# SERVICE BULLETIN

## SB1247

<b>ADDRESSEES</b>	: Owners and operators of coaches listed under 'Application'
<b>VEHICLE MODEL</b>	: TD925
<b>SYSTEM/SUBSYSTEM</b>	: Traction engine-Fuel system
<b>BULLETIN TYPE</b>	: Safety Recall NHTSA 12V-505
<b>DATE</b>	: November 27, 2012
<b>SUBJECT</b>	: <b>Fuel Pro-filter compartment – To install thicker base plate</b>
<b>TERMS &amp; CONDITIONS</b>	: Refer to the warranty section further in this Bulletin.

**Figure 2**

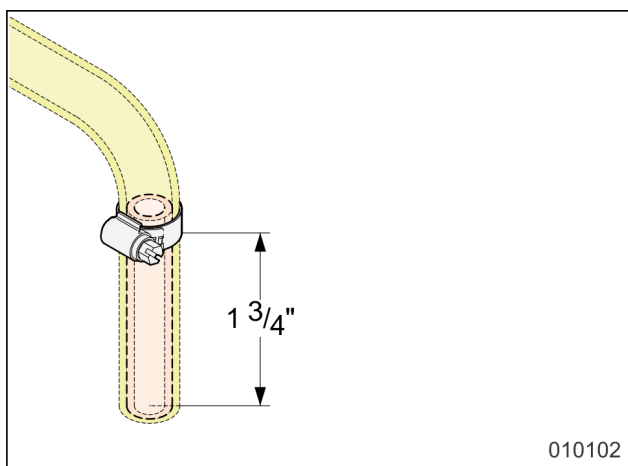
- 1) Remove and discard the existing base plate, bolts and washers.
- 2) Remove and discard the existing drain hose and barbed fitting from the bottom of the Fuel Pro filter drain valve.
- 3) Install the 90 Deg barbed elbow onto the bottom of the Fuel Pro filter drain valve. Point the barbed section towards the engine.
- 4) Install the yellow fuel hose onto the barbed elbow and secure with a clamp.
- 5) Fully insert the two inch of rigid PVC tubing into the free end of the yellow fuel hose.
- 6) Install a clamp over the free end of the yellow fuel hose and secure it 1  $\frac{3}{4}$ " away from the end (Figure 2).

**Figure 3**

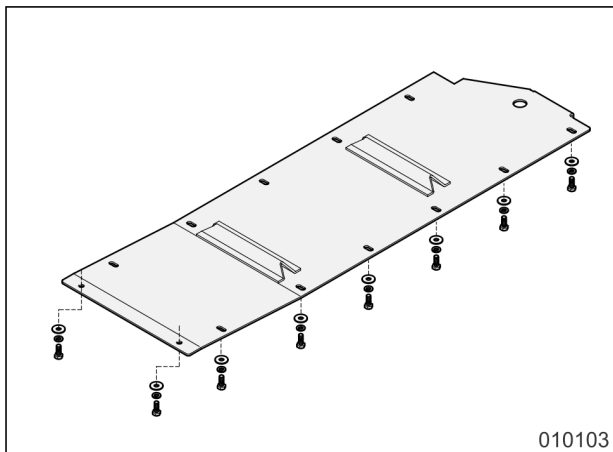
- 7) Install the new 3 mm thick base plate using M6 x 20 Class 10.9 cap screws, M6 lock washers, and M6 washers (Figure 3).

*NOTE: The two outboard screw holes must be match drilled in the plate. Coat the screw threads with Loctite 242 and tighten to a torque of 100 in-lbs. If any of the nutsert threads are stripped, drill it out and install the screw with a suitable nut and washer on the top side.*
